# 1722B – PROPOSAL FOR ENHANCED CONTROL FORMATS – V3 (FOLLOW-ON PRESENTATION FROM “LARGER BUS ID SIZE – V2”)

DON PANNELL  
21 APR 2020

# Larger bus\_id size – Proposal for CAN – old vs. new

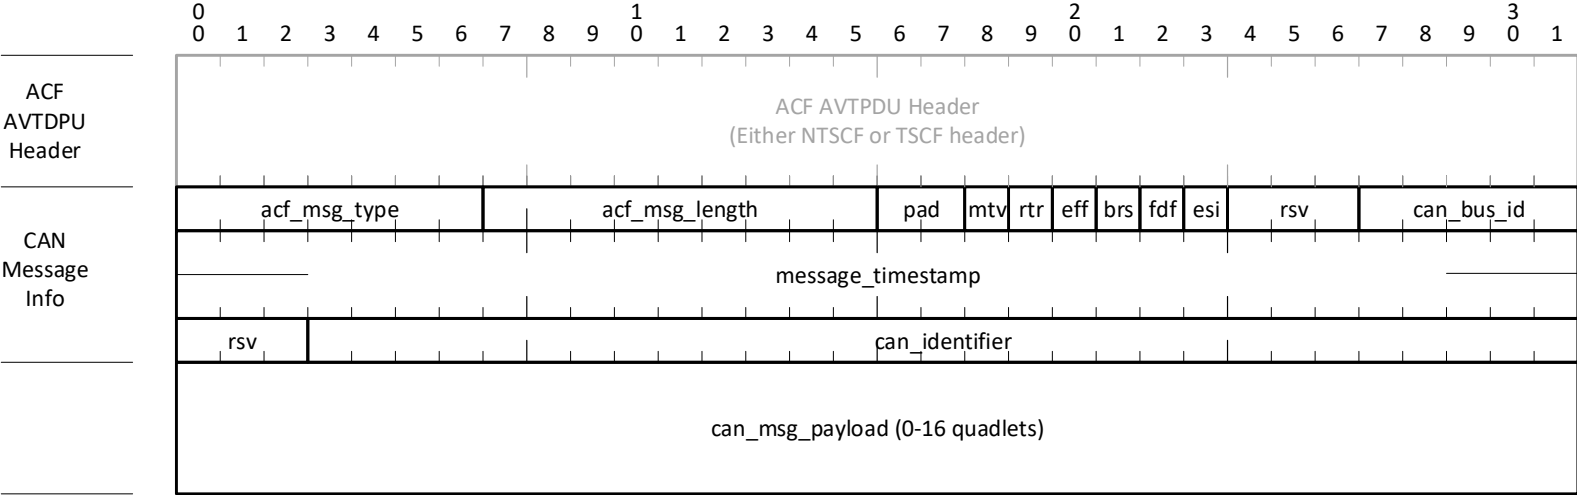
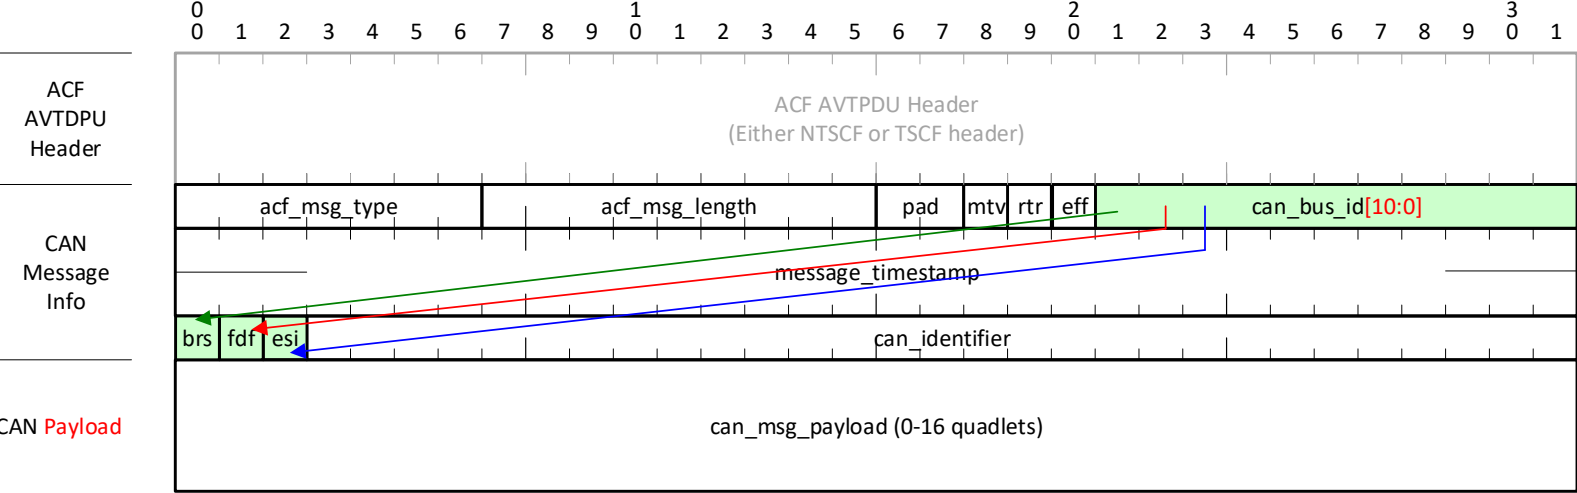
- Move **brs** (bit rate switch), **fdf** (flexible data rate), & **esi** (error state indicator) bits to previously reserved bits ~~& remove the brs (bit rate switch) bit as shown~~
- Extend the can\_bus\_id to ~~12~~ **11** bits (the lower 5 bits are in the same location)
- The CAN format requires the most bits, thus limiting the bus\_id to ~~12~~ **11** bits
- **rtr** (remote transmission request) & **eff** (extended frame format) are not moved

# Larger bus\_id size – Proposal for CAN BRIEF – old vs new

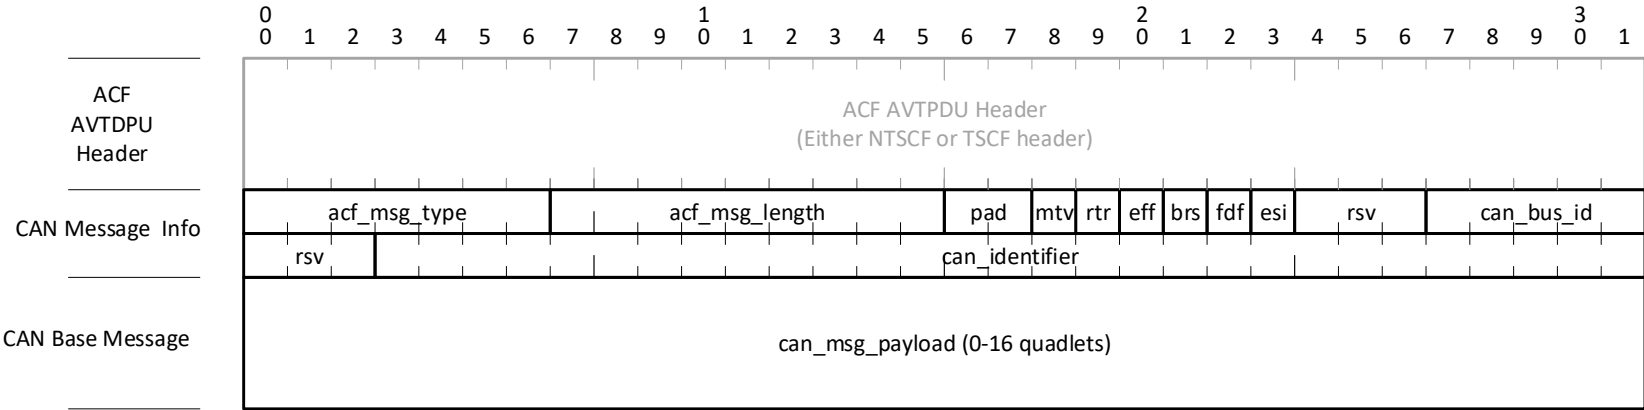
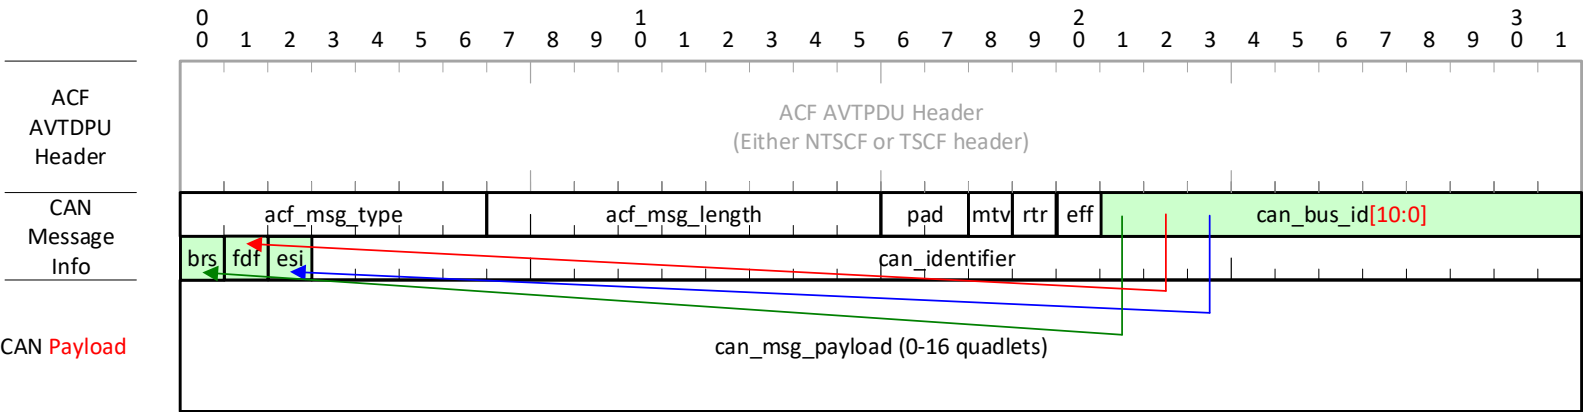
- CAN BRIEF gets the same changes as were done with CAN
- Move **brs (bit rate switch)**, **fdf (flexible data rate)**, & **esi (error state indicator)** bits to previously reserved bits ~~& remove the brs (bit rate switch) bit as shown~~
- Extend the can\_bus\_id to ~~12~~ **11** bits (the lower 5 bits are in the same location)
- **rtr (remote transmission request)** & **eff (extended frame format)** are not moved

# Larger bus\_id size – Proposal for LIN – old vs. new

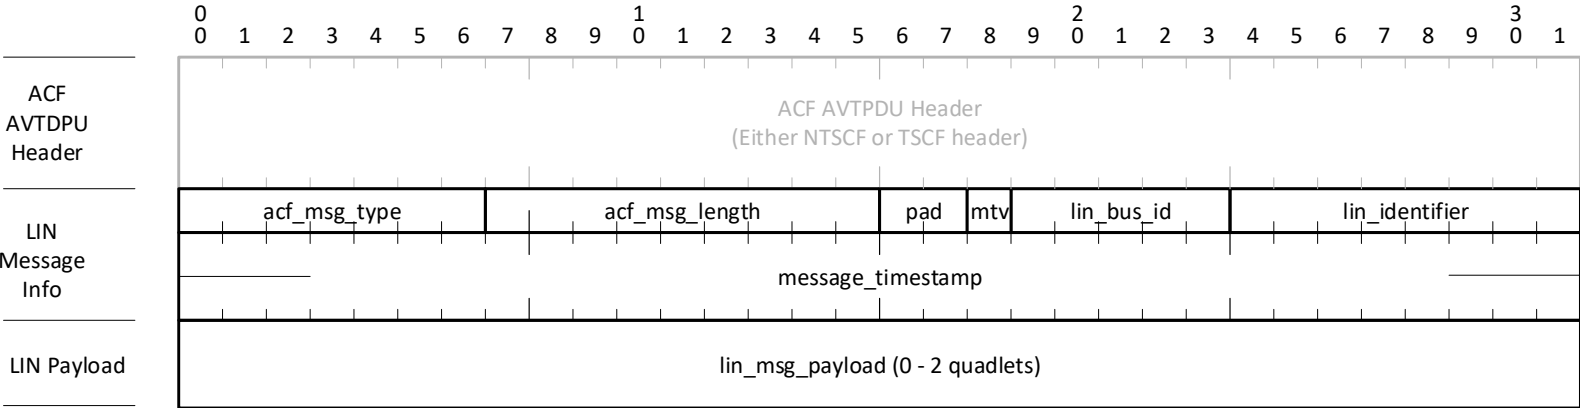
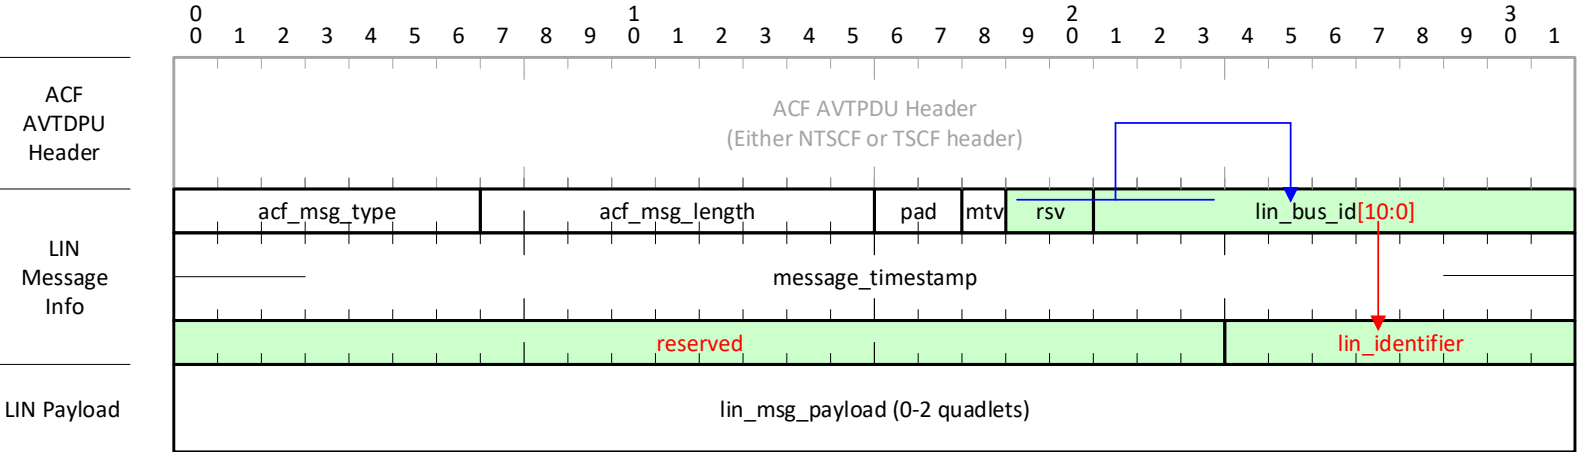
- LIN was fully packed, so a full quadlet needs to be added (added green quadlet)
- The lin\_identifier is moved to the new quadlet in the same area as the can\_identifier (although its not as large as CAN's)
- The lin\_bus\_id is shifted right by 8 bits & expanded to ~~12~~11 bits leaving 2 rsv bits

# Larger bus\_id size – Proposal for FlexRay – old vs. new

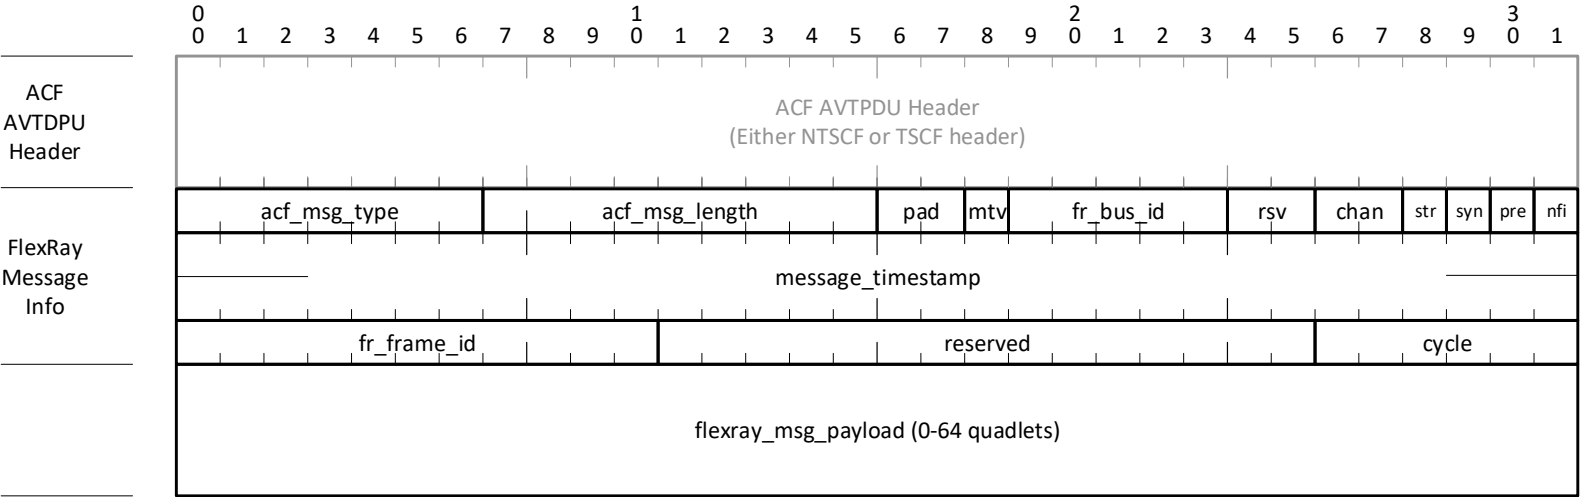
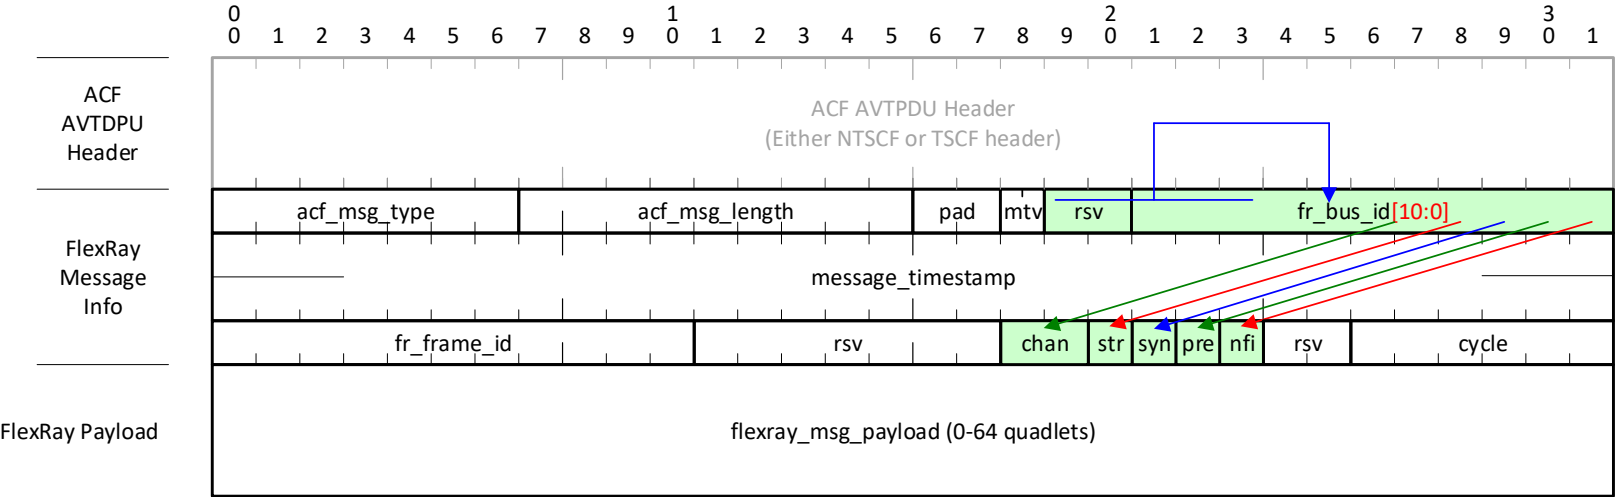
- Move the chan (source channel), str (startup), syn (sync), pre (payload preamble), & nfi (null frame indicator) bits to previously reserved bits as shown to free up room for the expanded fr\_bus\_id
- The fr\_bus\_id is shifted right by 8 bits & expanded to ~~12~~11 bits leaving 2 ~~a~~ rsv bits

# Larger bus\_id size – Proposal for MOST– old vs. new

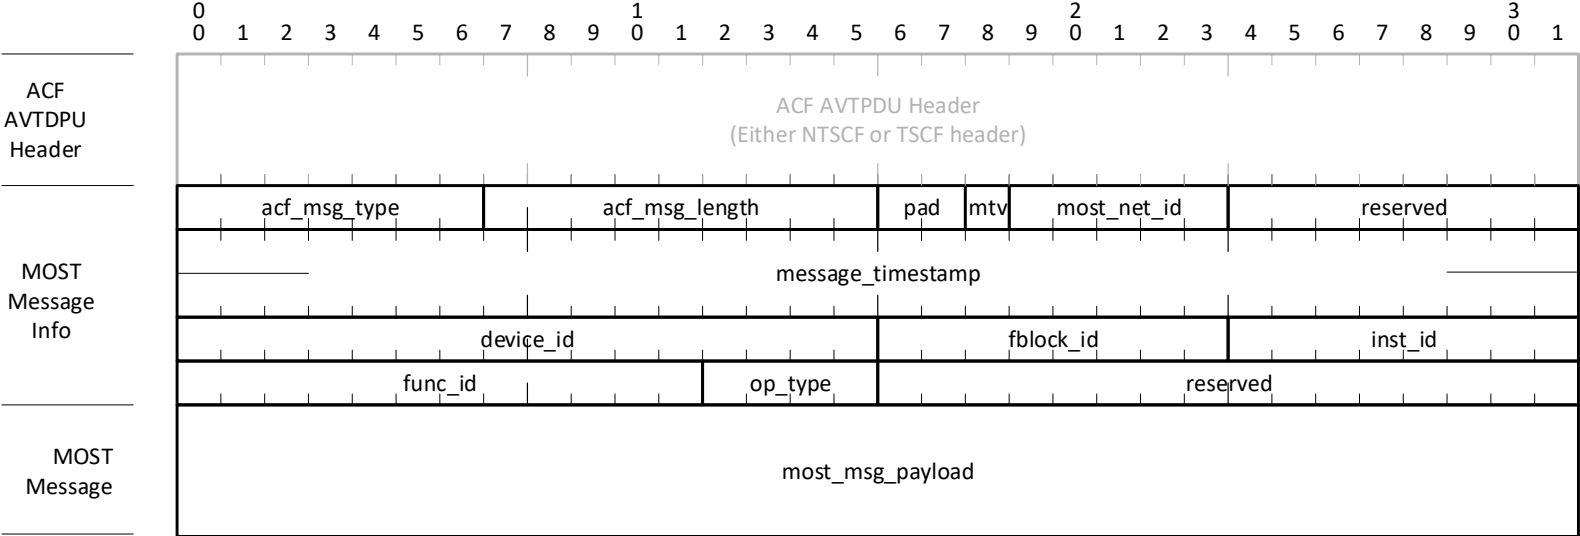
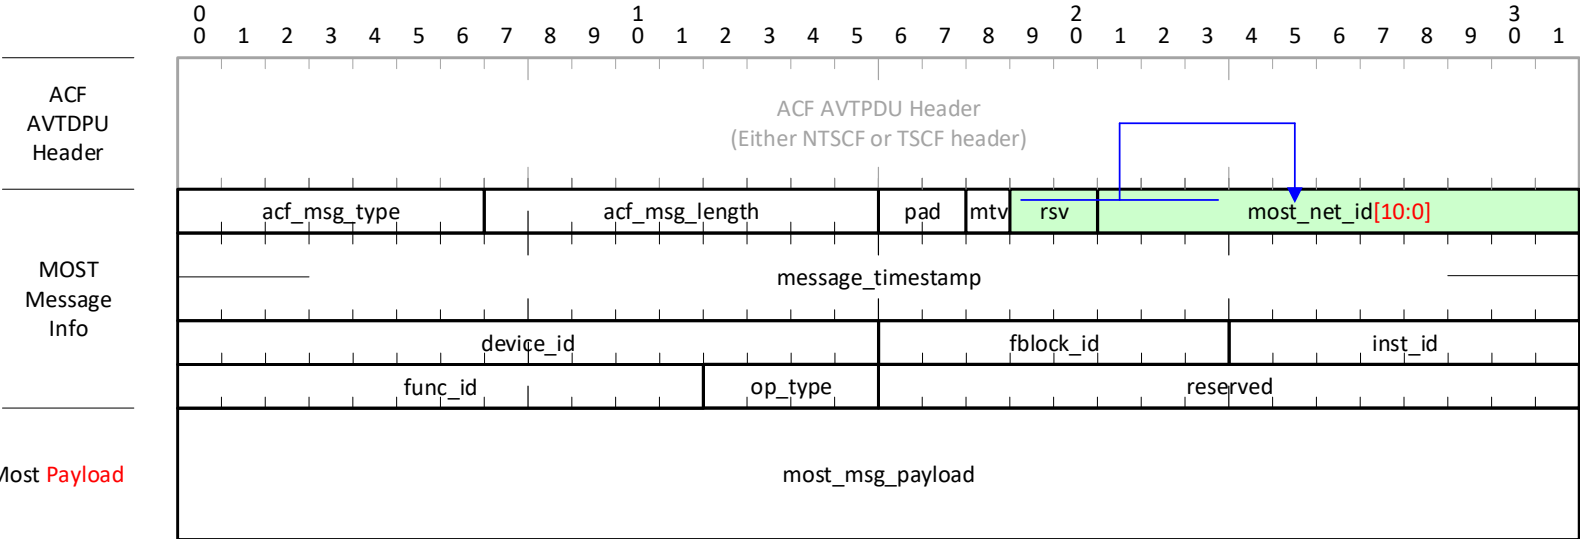
- The most\_net\_id is shifted right by 8 bits & expanded to ~~12~~11 bits leaving 2 ~~a~~ rsv bits
- The lower 8-bits of the new most\_net\_id previously was reserved bits

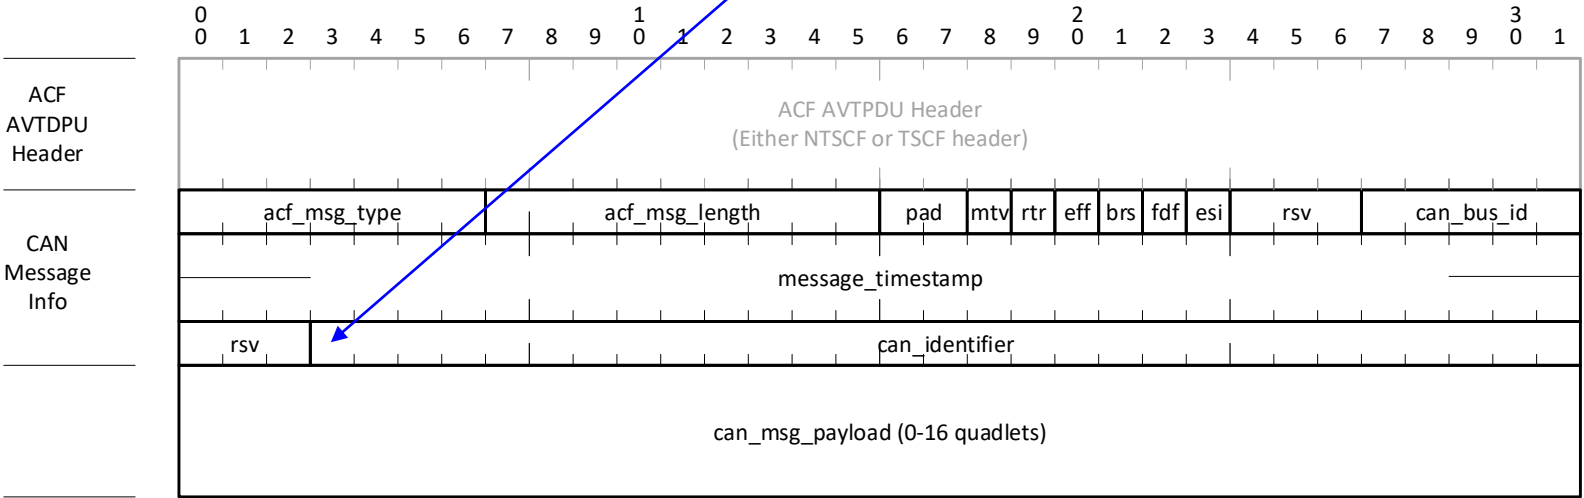
- Bit 03 in a 1722 CAN frame is the msb of the can\_idenfifier, correct? It should be!

Figure 55—Storage of an 11-bit CAN identifier

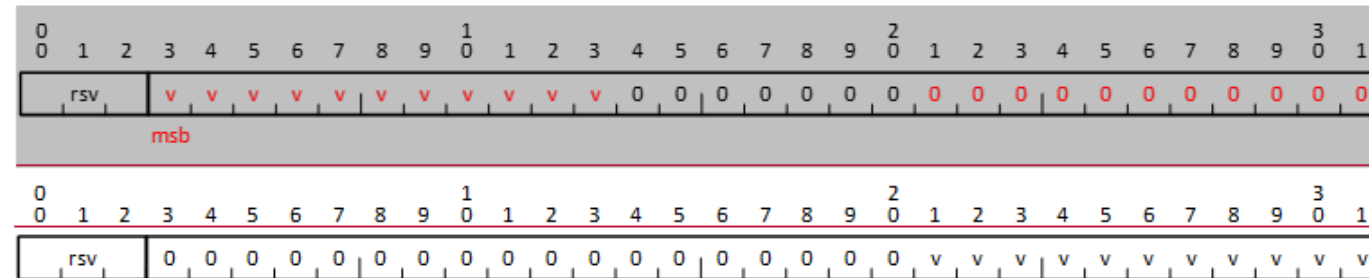
- Which is backwards as bit 3 is the msb!
- Or is bit 31 is the msb and all 29 bits are swizzled compared to convention,
- Or is bit 11 the msb for 11-bit IDs & bit 3 is the msb for 29-bit IDs

- This at least needs to be clarified in IEEE 1722b
  - The correct solution to me is define bit 3 in Fig 55 as the msb for both ID sizes, move the v's to bits 3:13 and update the text and figures accordingly:

The 29-bit **can\_identifier** field contains the CAN message identifier. CAN message identifiers are either 11 or 29 bits in length. The length of the **can\_identifier** field is communicated by the value of the **eff** bit (see 9.4.3.5). 11-bit CAN message identifiers are stored in bits ~~21~~3 through ~~31~~13 of the quadlet holding the **can\_identifier** field and the remaining bits of the field are set to zero (0). 29-bit CAN message identifiers occupy the entire 29-bit field. Storage of the 11-bit CAN identifier is shown in Figure 55. The letter *v* indicates a valid identifier bit.
